Woodridge ES
Change Order - Breakdown

RE: Woodridge Elementary School Major Building System Replacement
IOC #004 – Addendum #001, Dated 05/23/23

Project Name: Woodridge Elementary School Major Building System Replacement
Location: 4120 Cedar Ridge Trail. Stone Mountain, GA 30083
Architect: Cooper Carry
Description of Change: ADDENDUM #001, DATED 05/23/23

1 A2.10 OVERALL PLAN
SCALE: 1/16" = 1'-0"

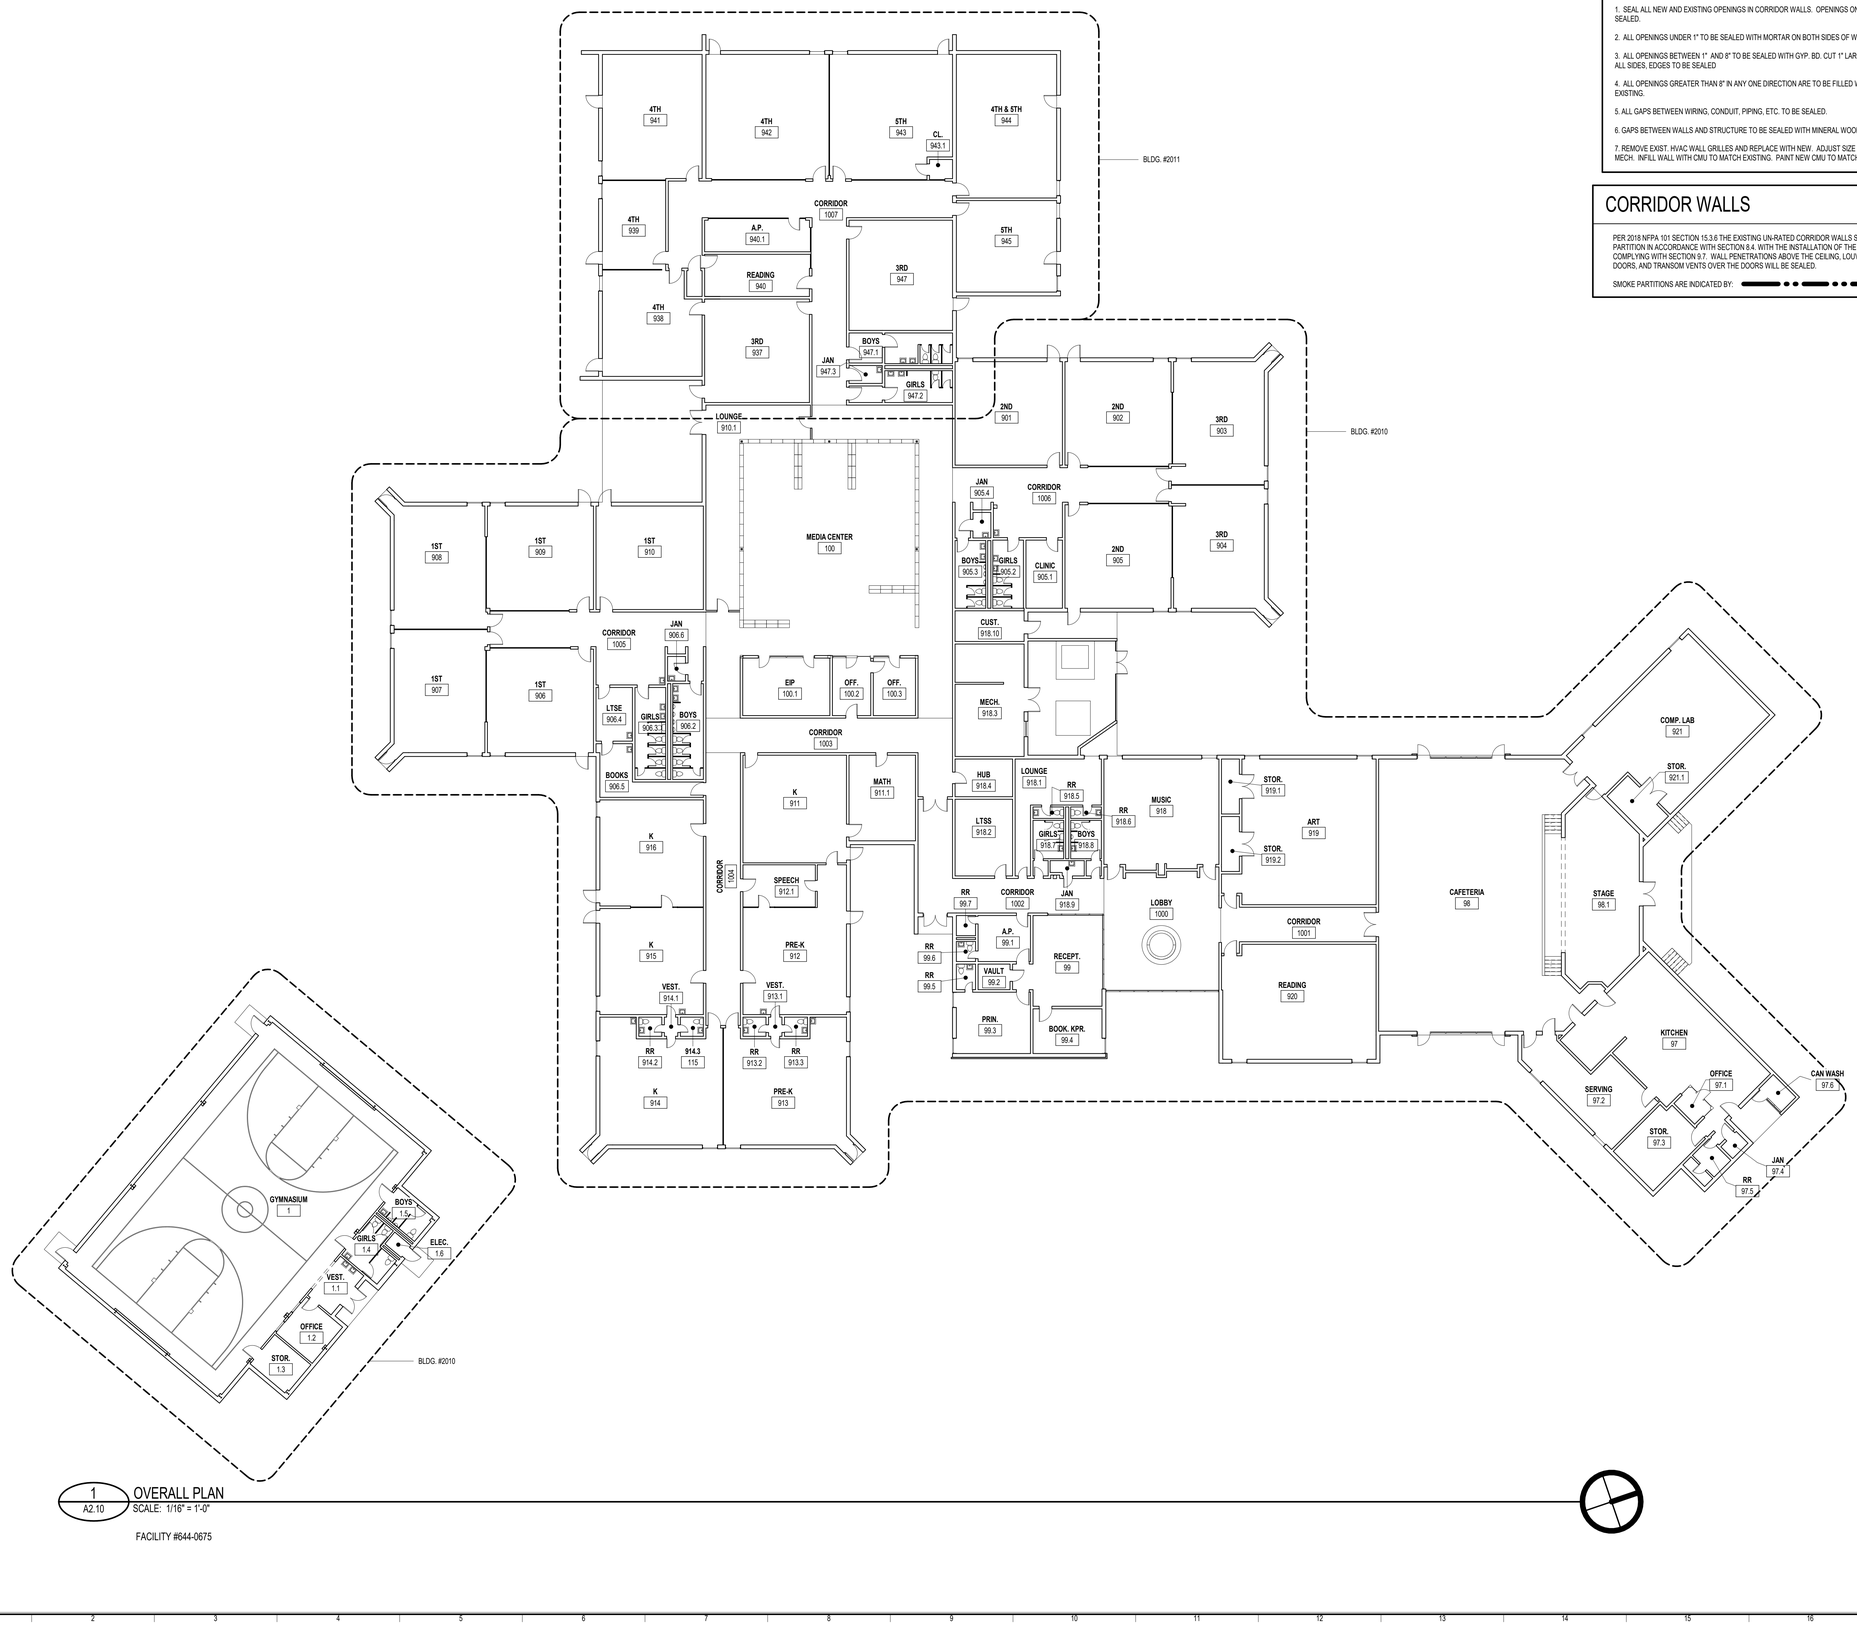
Attached, please find our proposal to furnish and install new interior identification signage per the overall floor plans A2.10. Currently the existing room identification signage is suspended from the existing ceiling grid (photo attached in backup for reference). Since we will be removing the existing ceilings and installing them with new ceilings, DCSD may want the new signage to be on the walls as standard with other schools. If DCSD would like us to remove the existing signage prior to demolition and salvage it for reuse, we can review this option as well.

1 ELECTRICAL PARTIAL LIGHTING PLAN - AREA B1

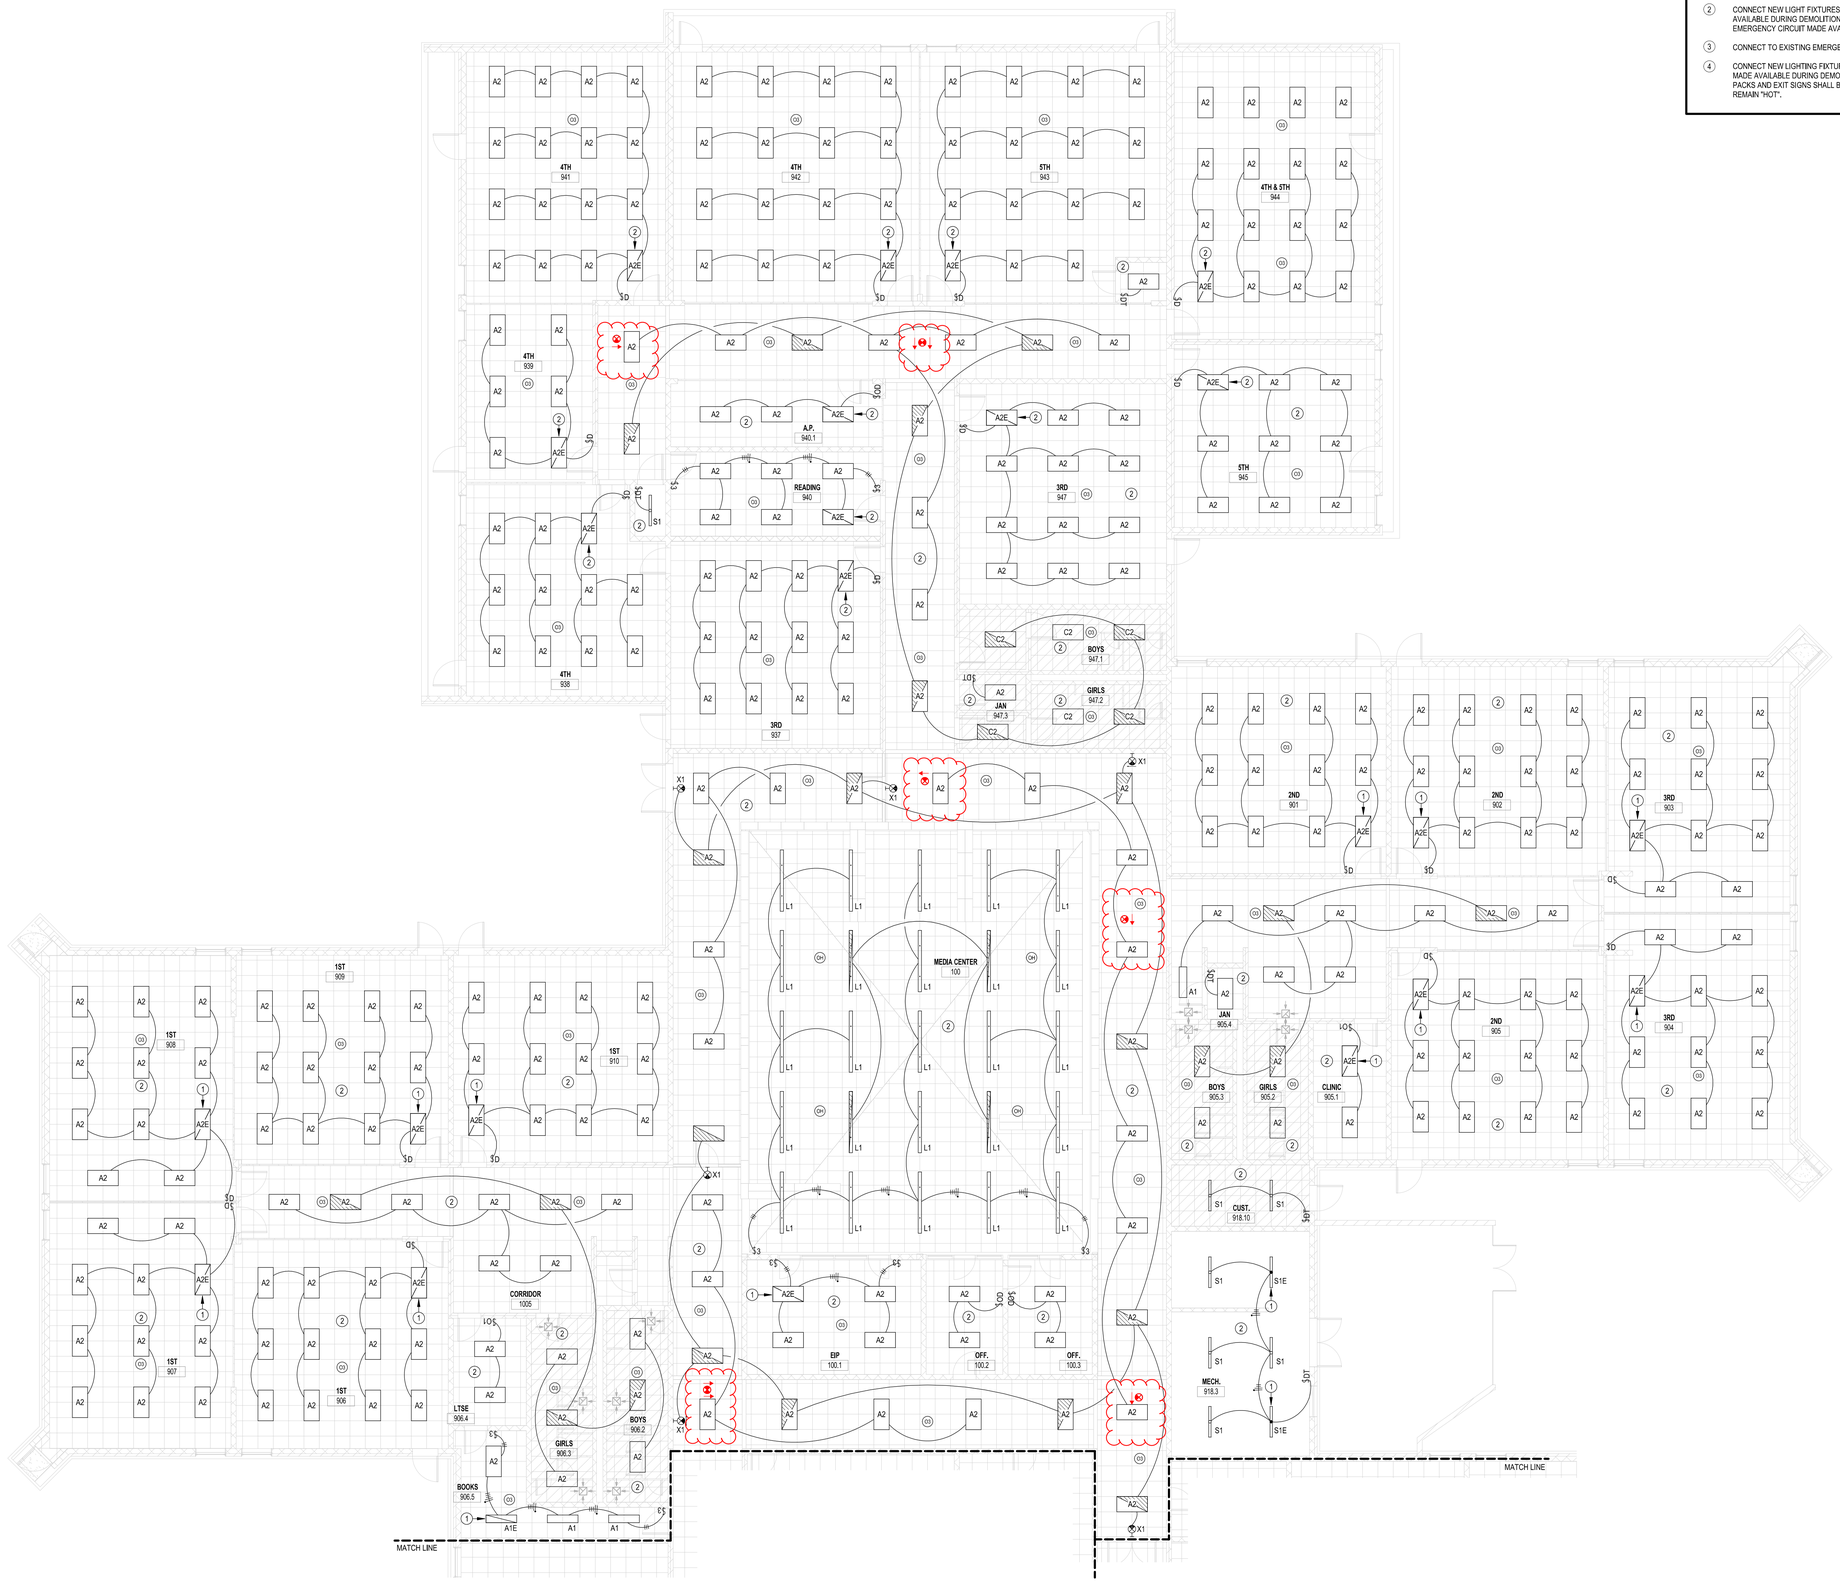
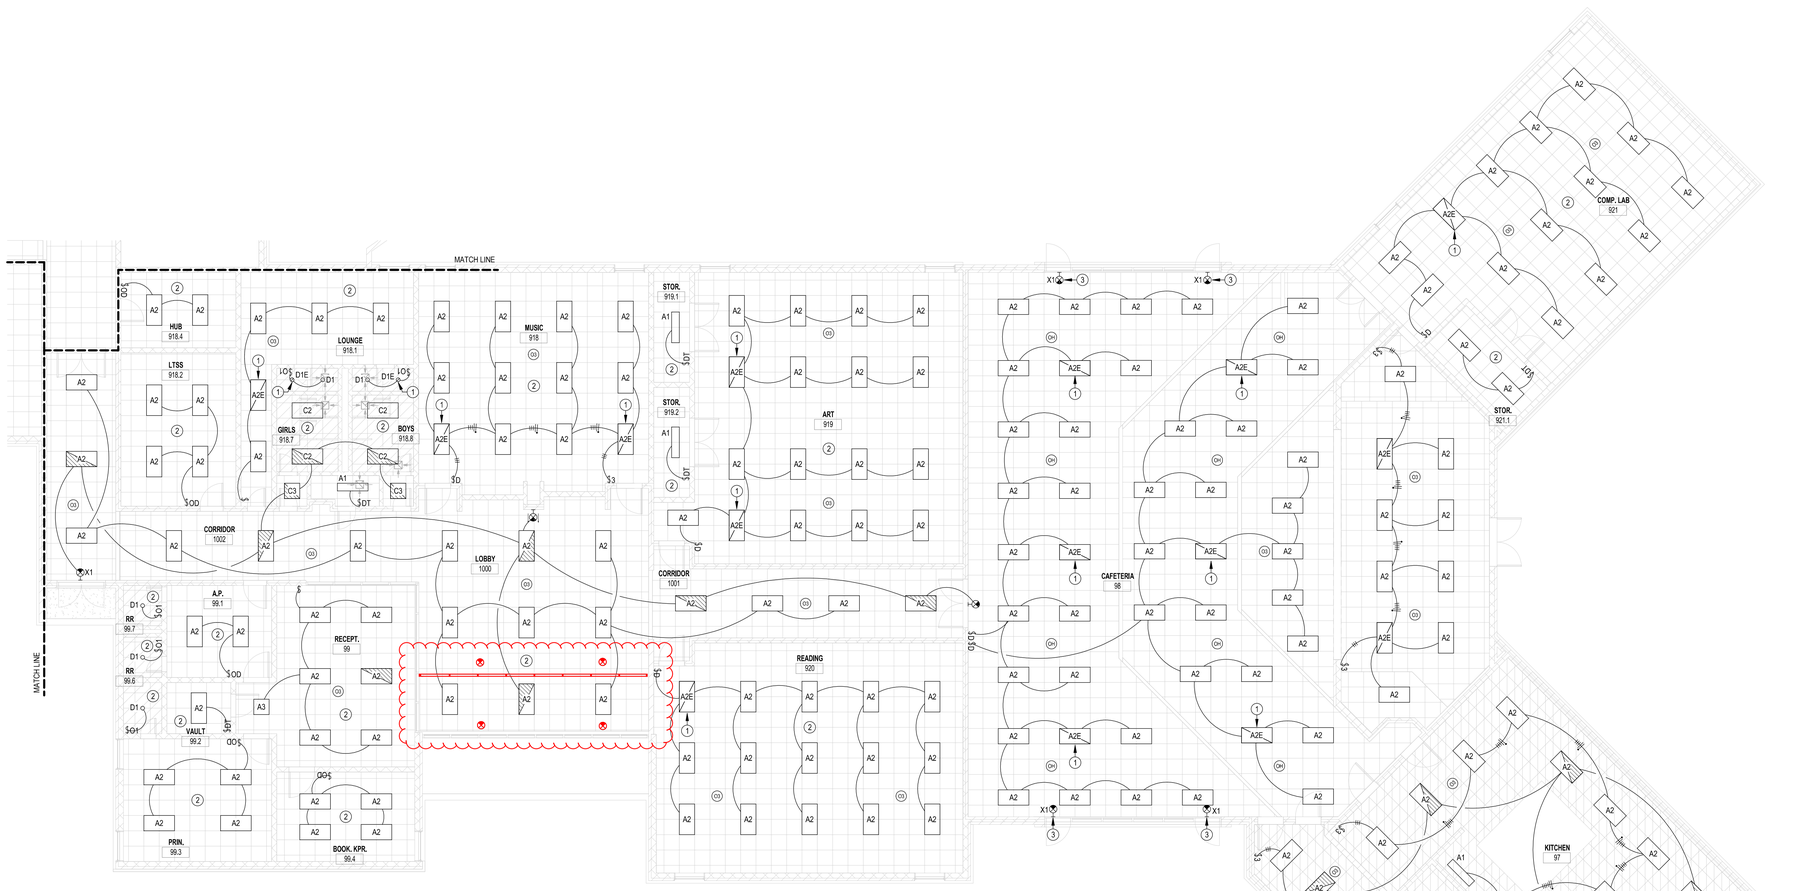
4) The Exit Lights will be placed per the attached Redlined Drawings, Plan Sheets E2.01 & E2.02.

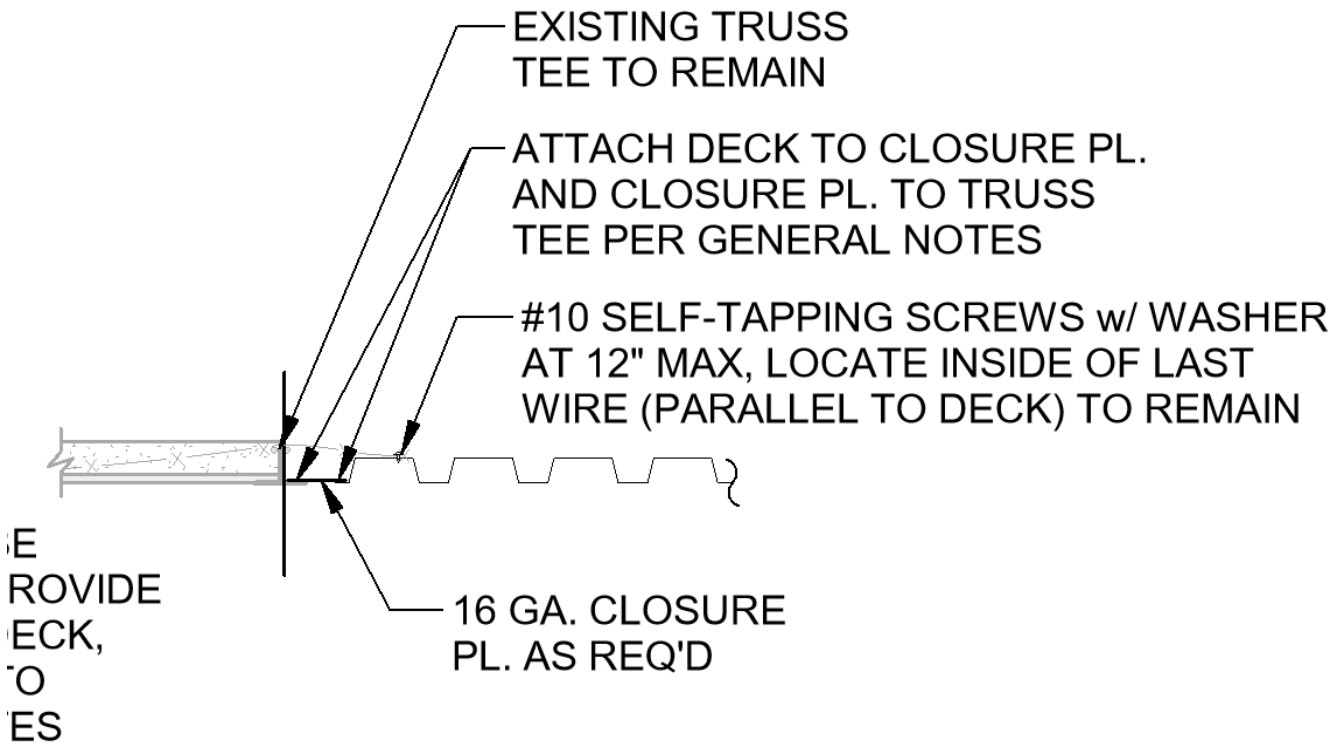
If the existing conditions exceed the single/double spans lengths provided, then it is acceptable to provide secondary support for the deck; however, it should not be attached to the existing bulb tees. An angle frame, similar to 1/S3.01 except comprised wholly of L3x3x1/4 angles, can be used to provide an intermediate support for the deck between joists/beams.

1 / S2.01 ROOF - AREA A FRAMING PLAN

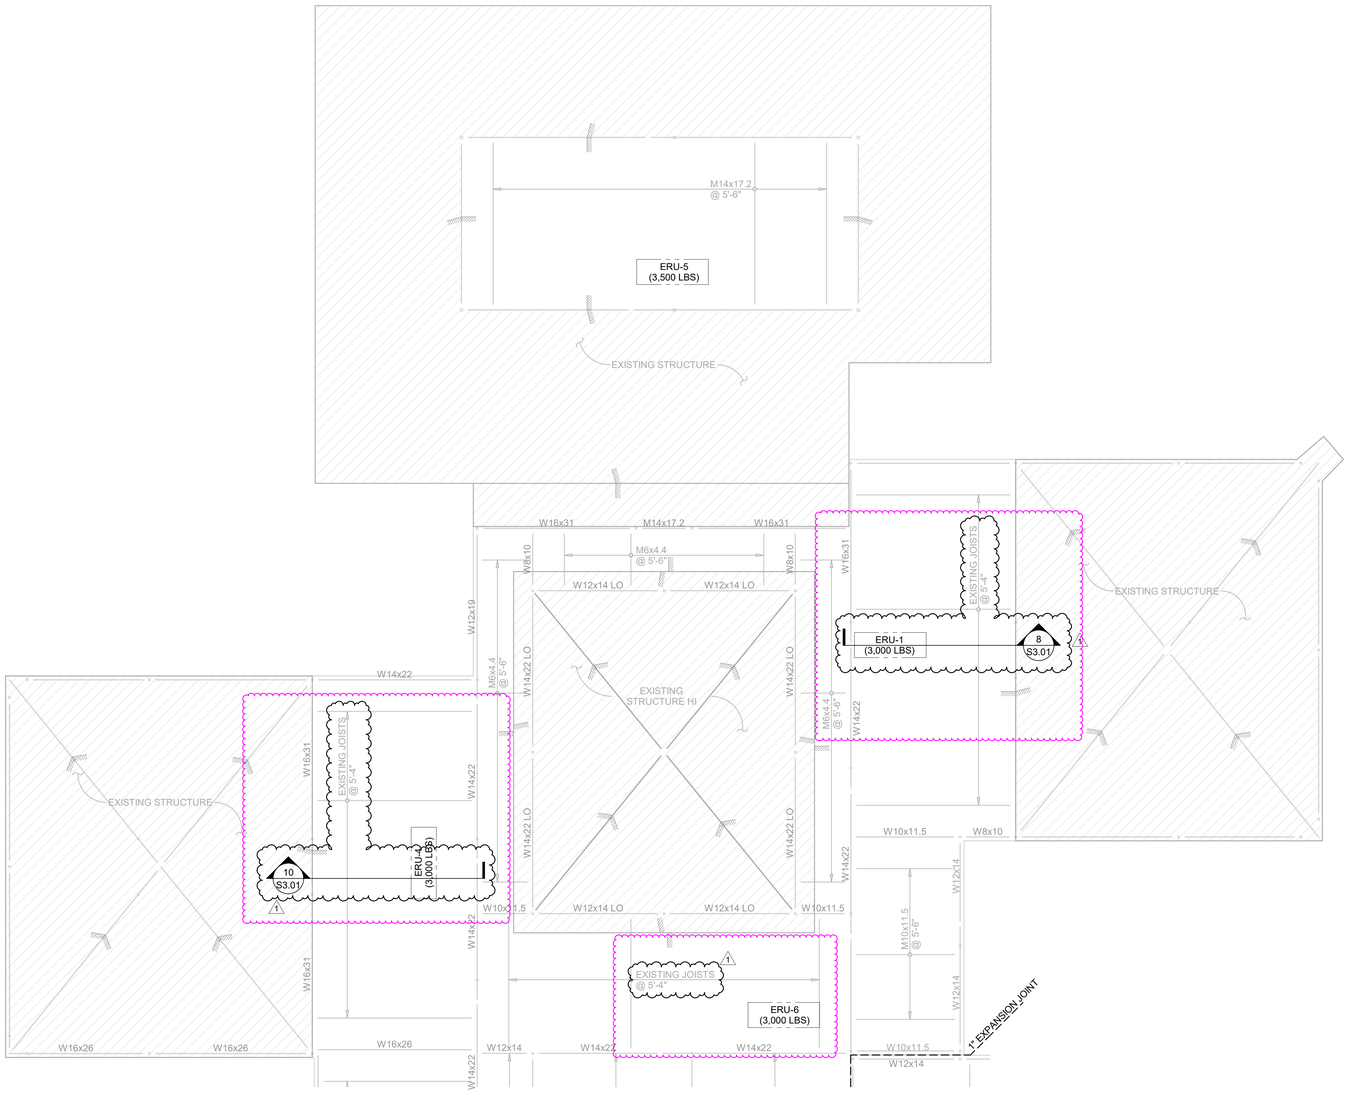
1.About (700 LF) of L2X2X3/16 Joist reinforcing angles are added per section-1, 8, 9, 10, 11, 12/S3.01.

2. (95) ~ Quantities of L7x4x1/2 seat angles are added per section 1/S3.01.

3. About (150 LF) of 3/8" Diameter reinforcing rod are newly added per section 10/S3.01.
